BELL SYSTEM PRACTICES
Station Installation and Maintenance

ADDENDUM C32.505
Issue 1, 5-31-46
AT&T Co Provisional

TELEPHONE SETS
NORTH ELECTRIC

Fig. 1

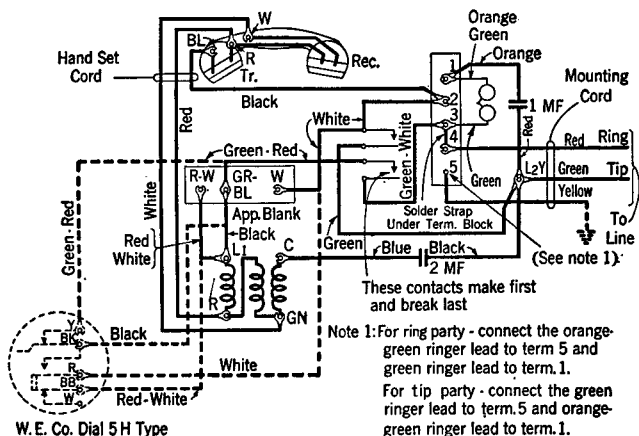
1.02 Paragraphs 3.01 and 3.02 of Section C32.505 are replaced by Paragraphs 3.01 and 3.02 herein which give improved connections for North Electric sets, and the code for sets with these connections is given in Paragraph 1.03. A note is added to Paragraph 2.01 of the Section.

3.01 The connections for North Electric telephone sets are shown in Fig. 1 herein which replaces Fig. 1 of the section. The new connections should be provided for all new installations, reinstallations and additions of dials to the sets. Likewise whenever customer complaints of dial or switch clicks

3.02 The diagram in Fig. 1 shows the line and ringer connections are for bridged ringing lines. Line and ringer connections for bridged and grounded ringing lines of the classes of service for which the set is used are given in Table 1.

<u>Connections</u>	<u>Ringer Leads</u>		<u>Mtg. Cord</u>		
	<u>OR-GN</u>	<u>GN</u>	<u>R</u>	<u>GN</u>	<u>Y</u>
Bridged	1	L1	L1	L2Y	5
*Ring Party	5	1	L2Y	L1	5
*Tip Party	1	5	L1	L2Y	5
